Plan Commission

Special Meeting

Agenda

Monday, April 3, 2017	7:00 PM	De Pere City Hall Council Chambers
------------------------------	----------------	---

SHEET NO.
3 of 5

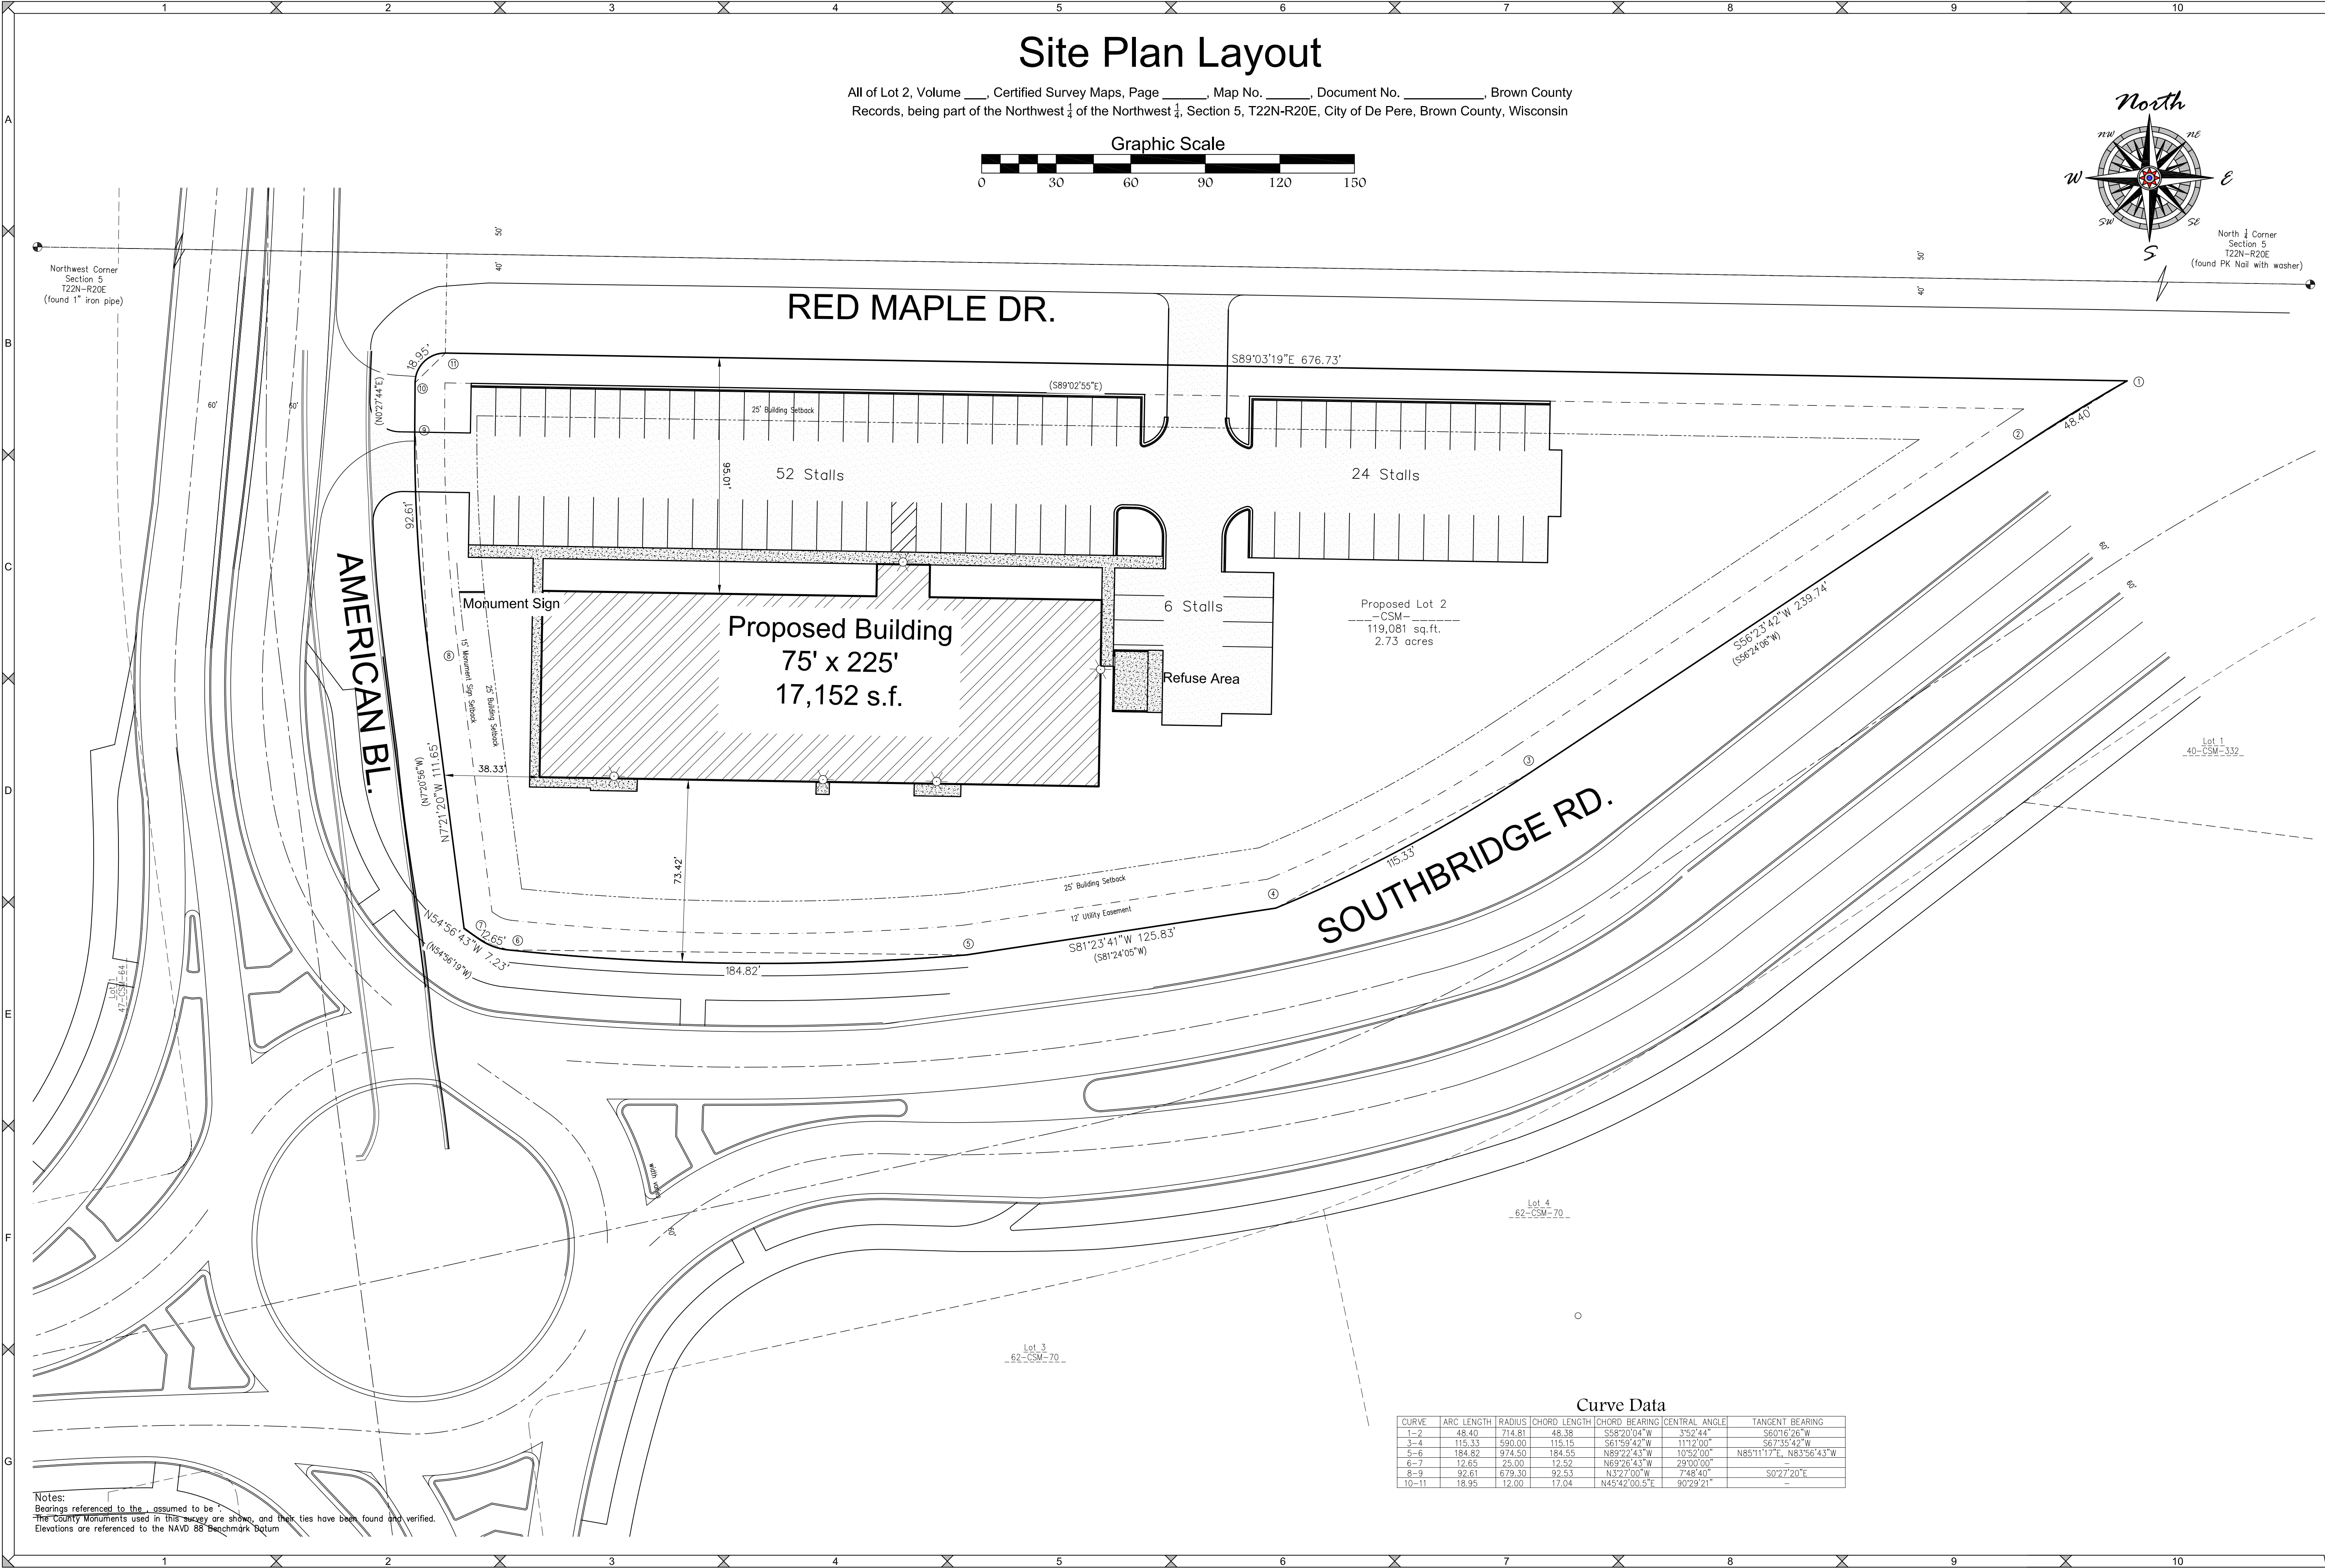
1. The monument sign shown on the site plan is for sample purposes only. A separate sign permit is required for the signage.
2. Properly revise Site Plan sheet 5 of 5 to demonstrate the required number of parking stalls.

3. Properly identify that all parking lots are bound by curbs.
4. Clarify the location of the dumpster on the site plans. The Landscape plan shows the dumpster in a different location than the rest of the site plan.

6. This project will be evaluated as a 'health club' which requires 10 spaces plus 1 for every 200 square feet. (89 spaces). Staff supports the 82 spaces shown on the plan because additional land is available on site for expansion to the east. A condition of the project will permit the City to order in additional parking if on-site parking is not adequate in the future.

7. To reduce pavement, recommend that the parking stall width be reduced from 10-feet wide down to 8.5-feet or 9-feet for 98% of the stalls, and 2% of the stalls should be 12-feet wide for ADA access stalls. Stall depth for all stalls can be reduced from 20-feet deep to 18.5-feet deep, per Code 14.55. The 24-foot driveline is correct.

ELEVATIONS SCALE : 1/8" = 1'-0"

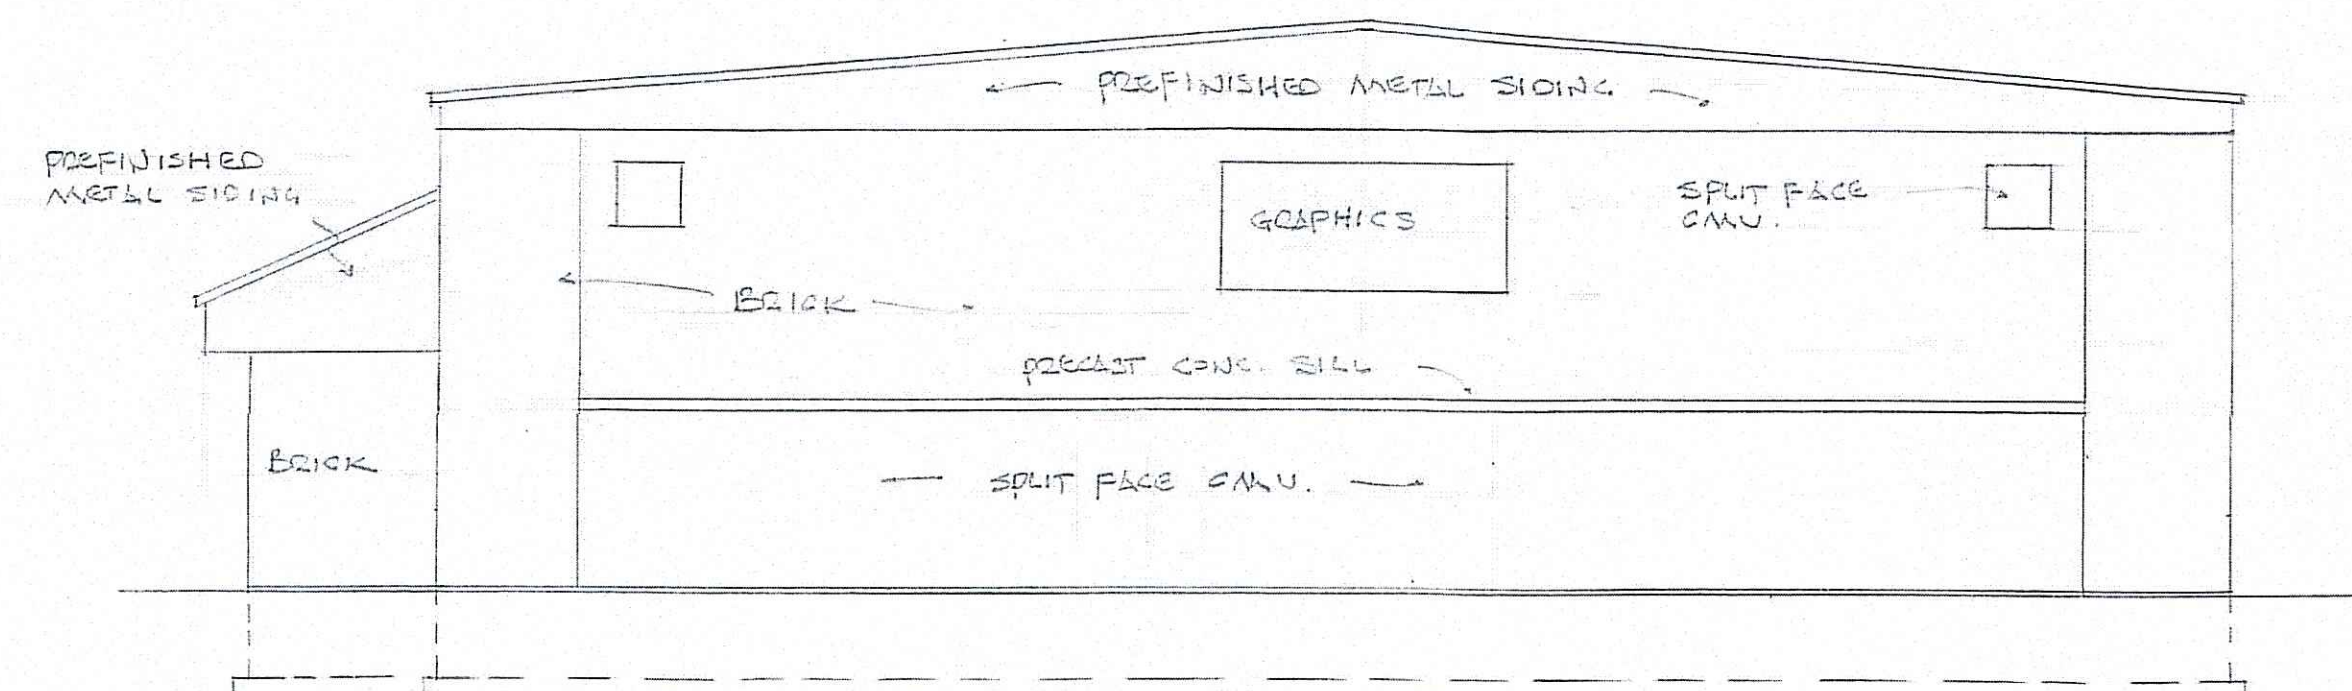
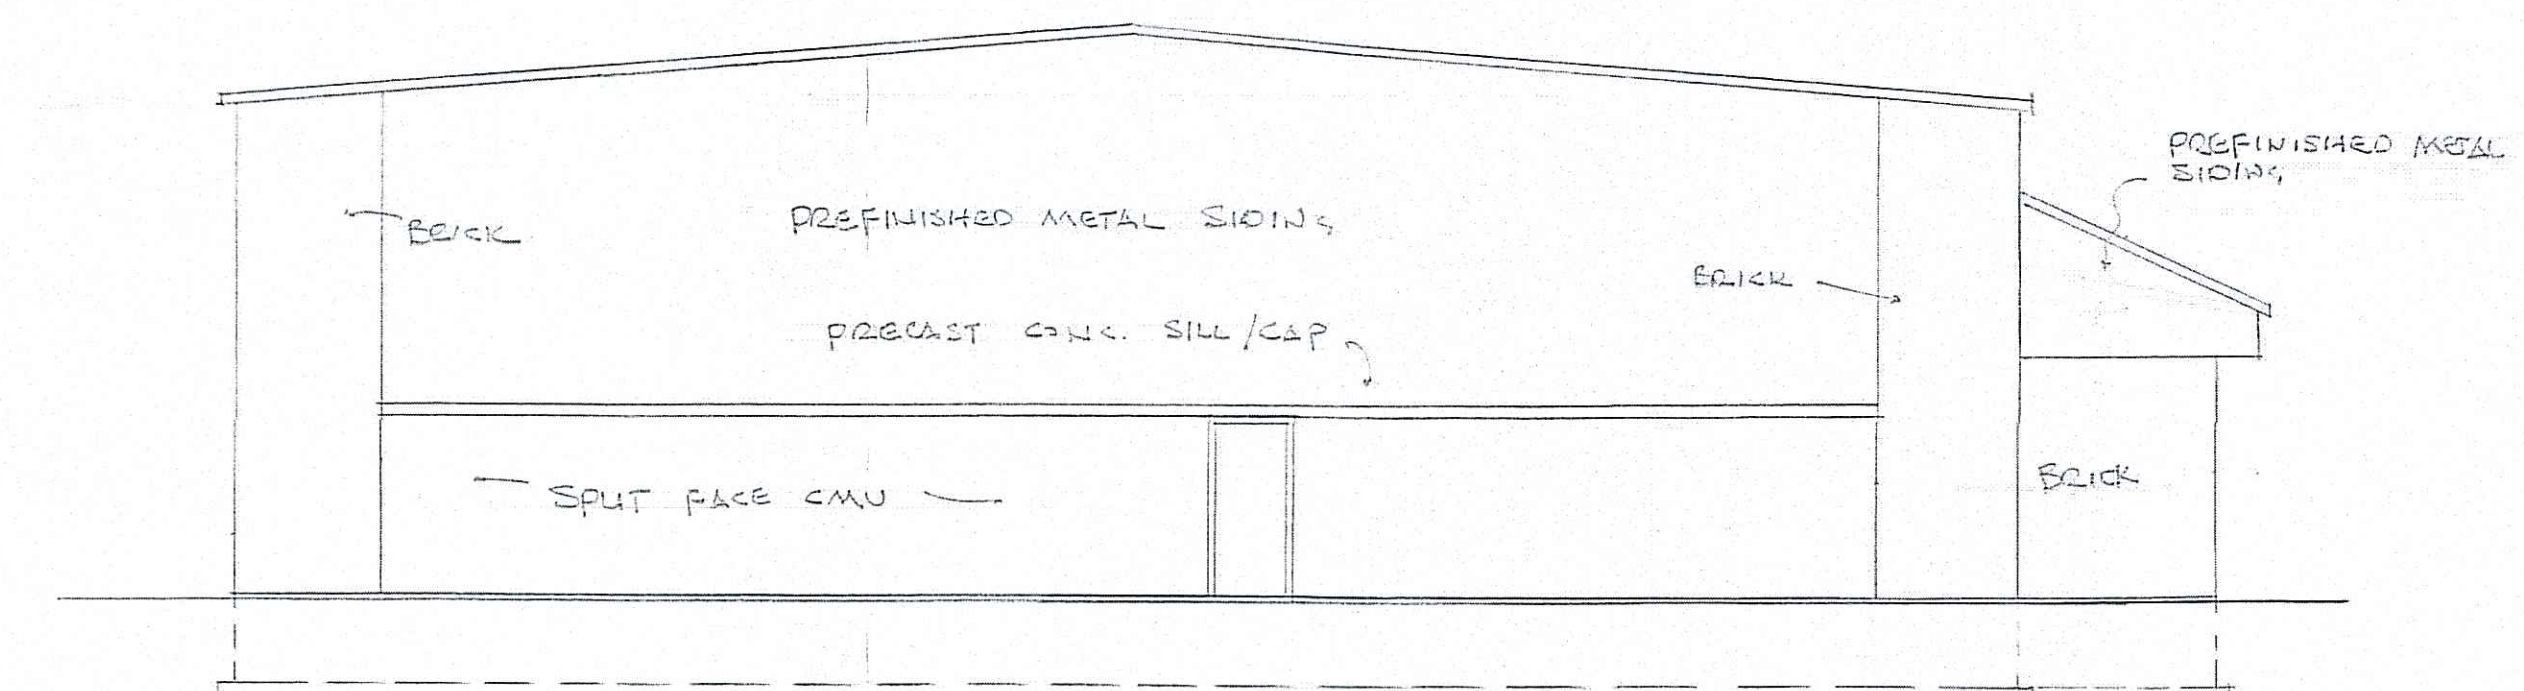
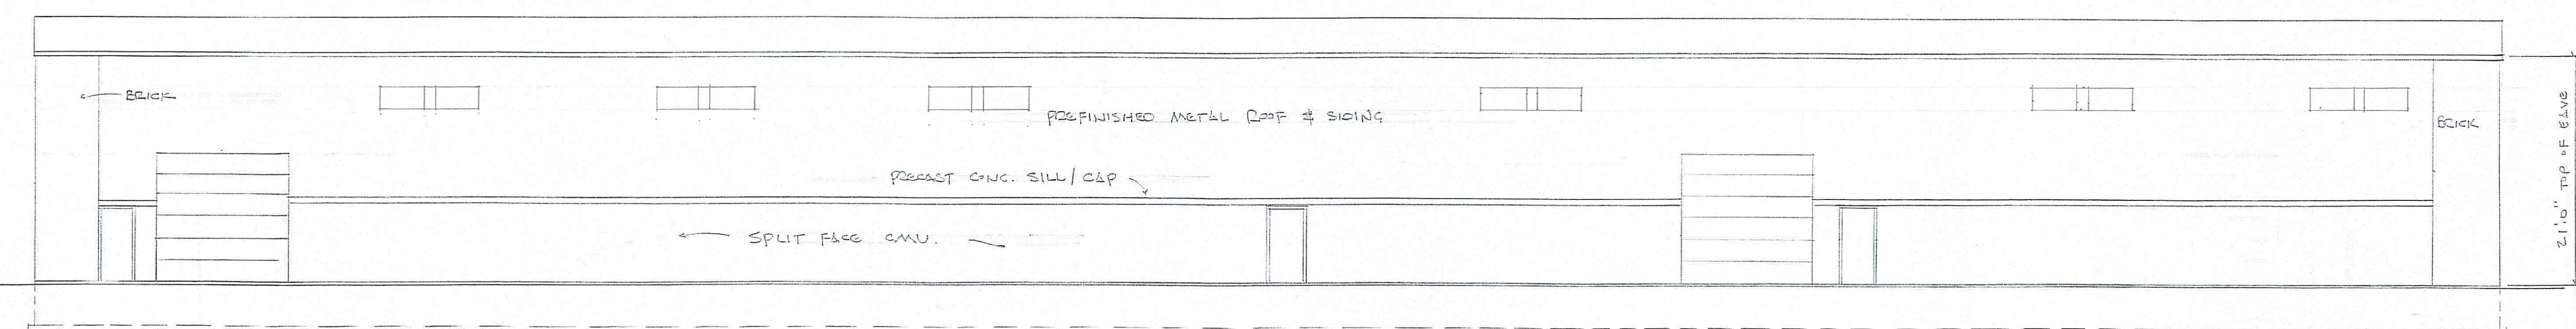
8. To break up the mass of the rear wall, visible to Southbridge Road, add two or more brick columns, similar to those shown on the corners and front of the building.
